Subject: SAS-Multiple Connections on Wide Ports

1 Overview

Placing connections on SAS ports with multiple links is not very well defined in SAS rev 01. This is a proposal to add in figures and text into the model section on SAS that describes that function.

Figure 1 — Multiple connections example

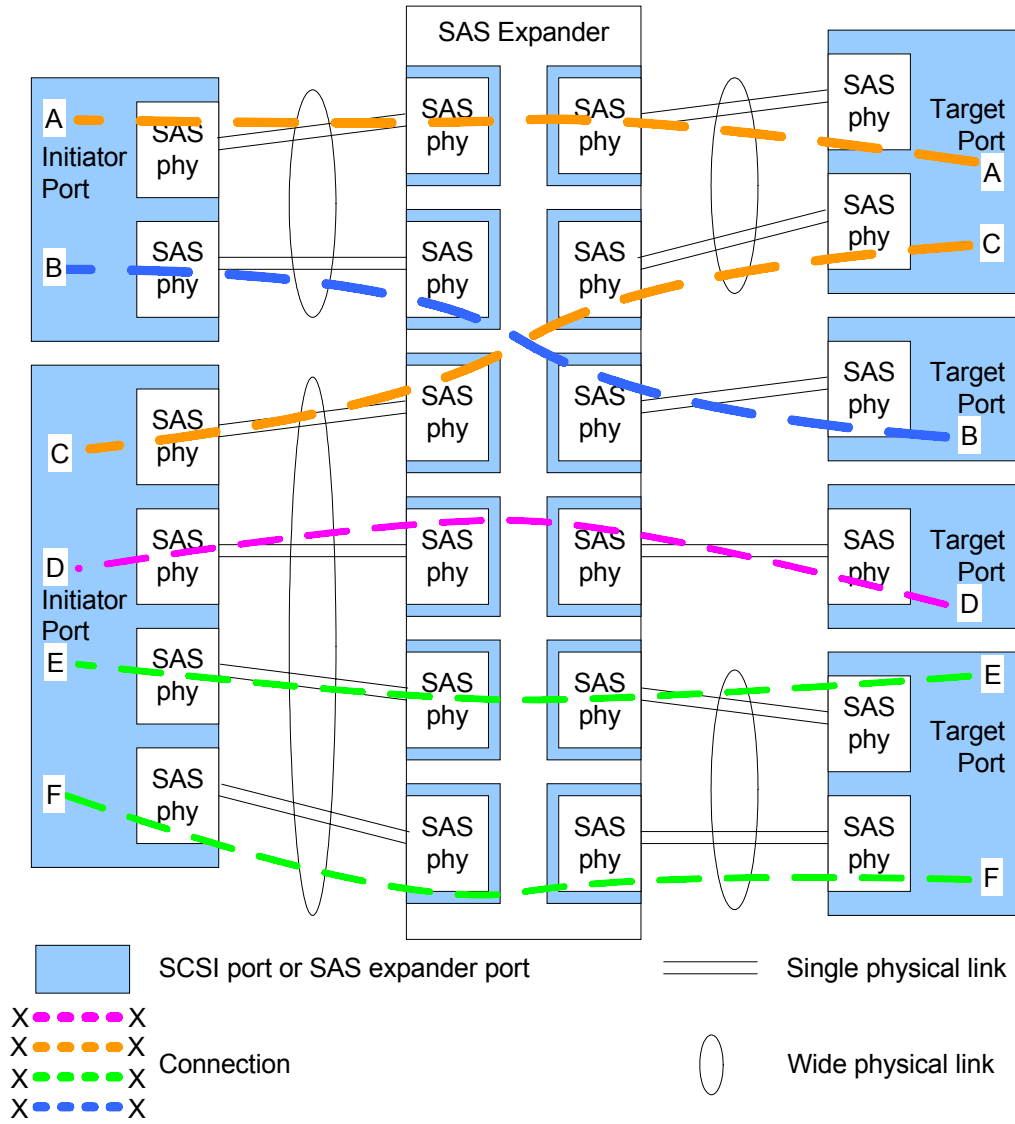
See figure 1 for examples of connections between wide ports.

In figure 1 all the connections shown may occur simultaneously.

In figure 1:

- a) the connections labeled A and B are an example of one initiator port with connections to multiple target ports;
- b) the connections labeled A and C are an example of one target port with connections to multiple initiator ports;
- c) the connections labeled E and F are an example of multiple connections between one initiator port and one target port; and
- d) the connections labeled C, D, E, and F are an example of one initiator port with connections to multiple target ports with one of those target ports having multiple connections with that initiator port.
